CONTRACT CHANGE ORDER FORM

CITY OF LAKE ELMO, MINNESOTA
EAGLE POINT BLVD STREET & UTILITY IMPROVEMENTS
PROJECT NO. 2015.120

CHANGE ORDER NO. 1 **DATE:** August 4, 2015

RECORD NO. SHEET NO. 13

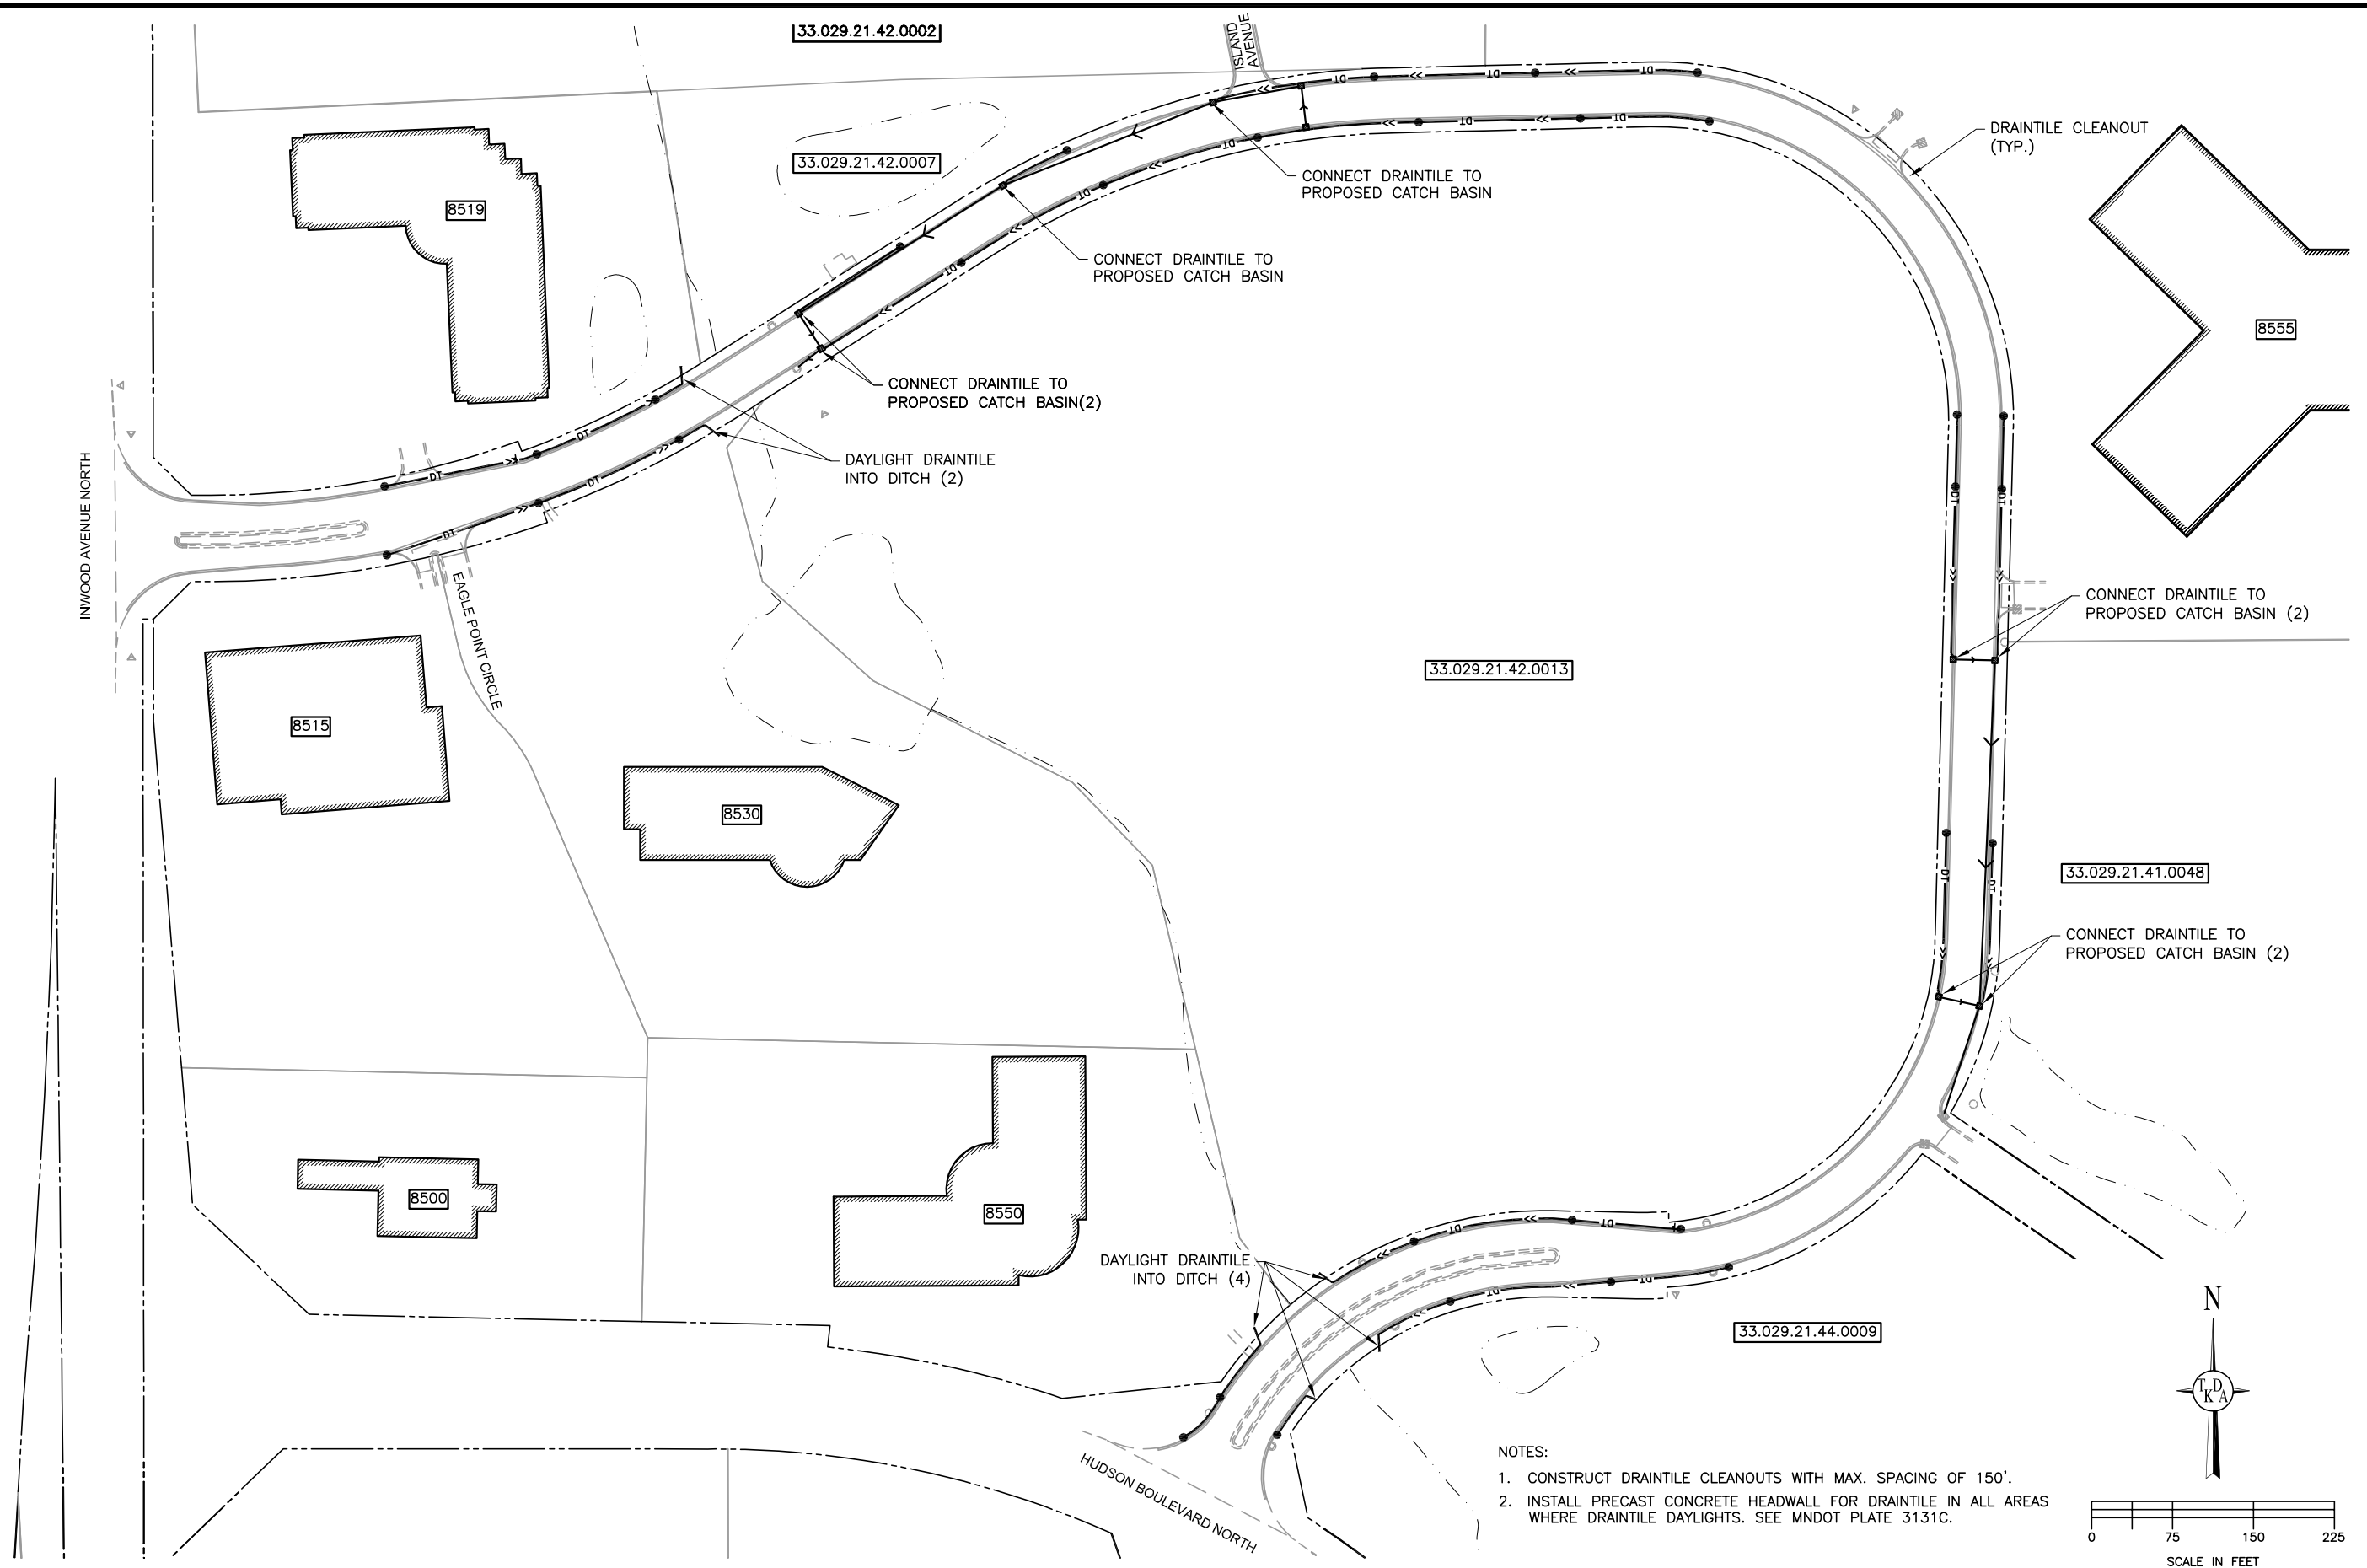
This change order reduces the draitile from 6,660 feet to 3,810 feet by eliminating draitile in certain locations within the street sub-base. With high bid prices on draitile, value engineering was completed to specify draitile at strategic locations along the corridor. Furthermore draitile cleanouts were reduced from 50 to 31 due to the reduction in length.

Attachments (list documents supporting change): Revised Sheet No. 13 dated 07.28.2015

NO.	DATE	BY	DESCRIPTION OF REVISIONS
1	7/28/2015	MOB	C.O. #1
